DATE: July 15, 2020

SUBJECT: **Addendum No. 1**
Rockwell Police Department
Rockwell, NC 28138

FROM: Ramsay Burgin Smith Architects, Inc.
225 North Main Street - Suite 501
Salisbury, NC 28144

1 PARTIAL WALL SECTION

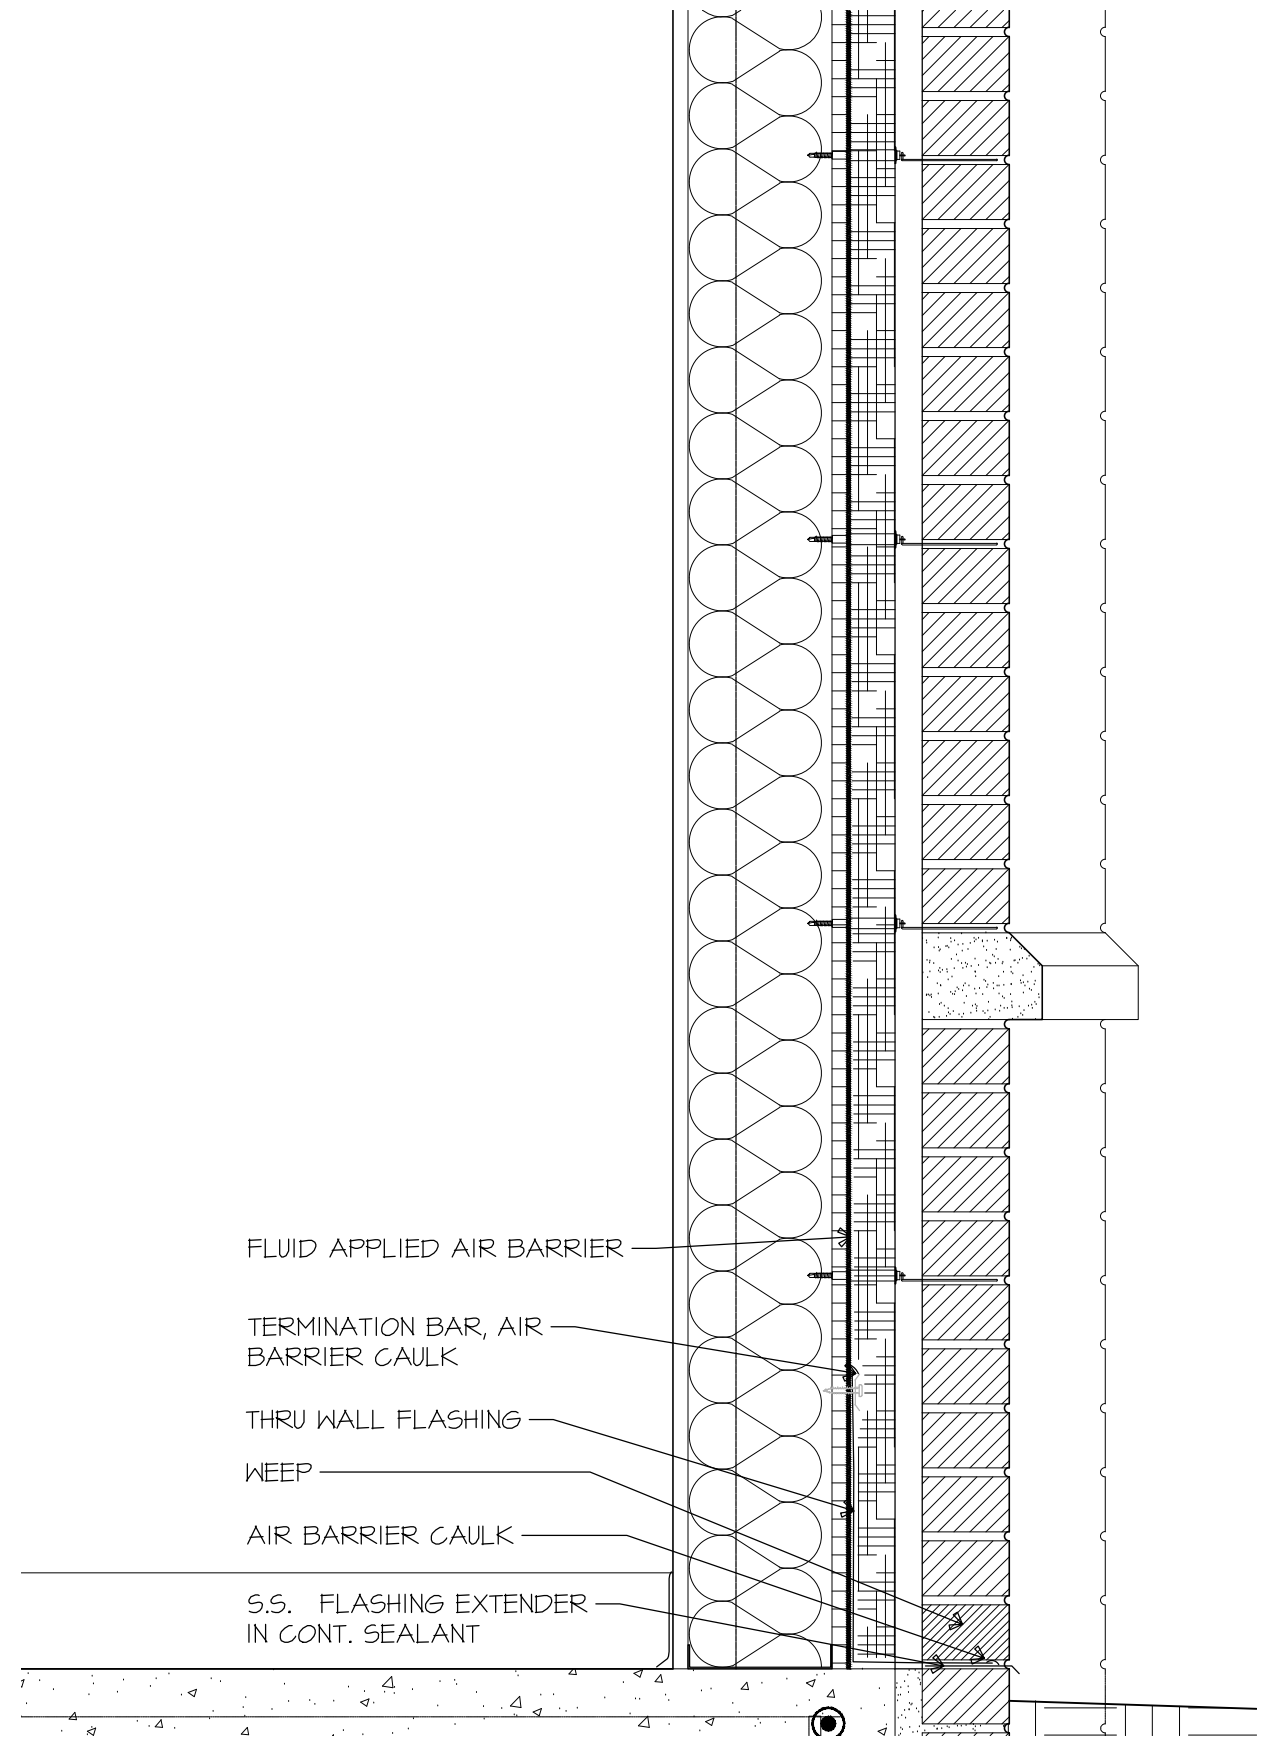
ITEM #13: Reference Drawing Sheet 1/A4.1 & A4.2: Enlarged Partial Wall Sections

See attached Sht ABD1 Details 1 & 2 w/ extra noting for application of the air barrier and thru wall flashing.

17 PLATE DETAIL

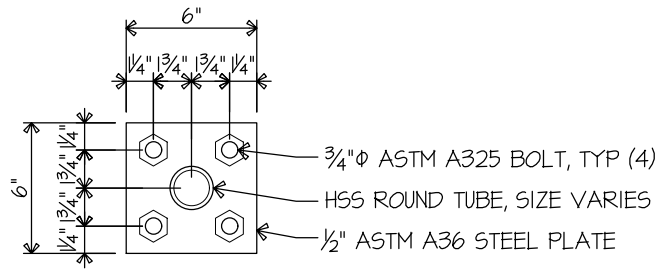
An Antenna Support Pipe Post is being added to the roof structure located just above the IT Room 11 for the Owner to set up their communications antenna system. See the required antenna mount and installation drawing along with the necessary roof flashing details.

16 SECTION @ ROOF ANTENNA MOUNT

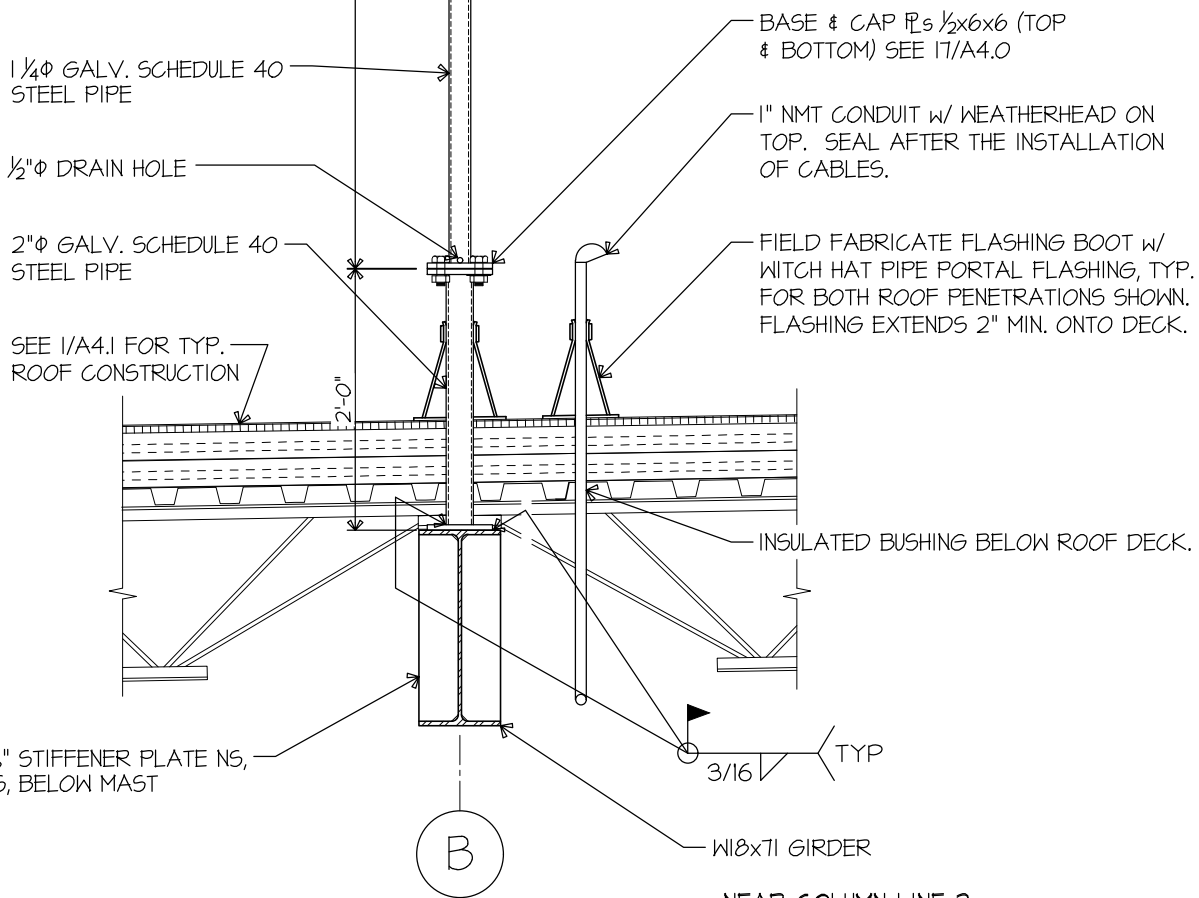
ITEM #15: Reference the attached Bulletin Drawing Sheet SBD1:
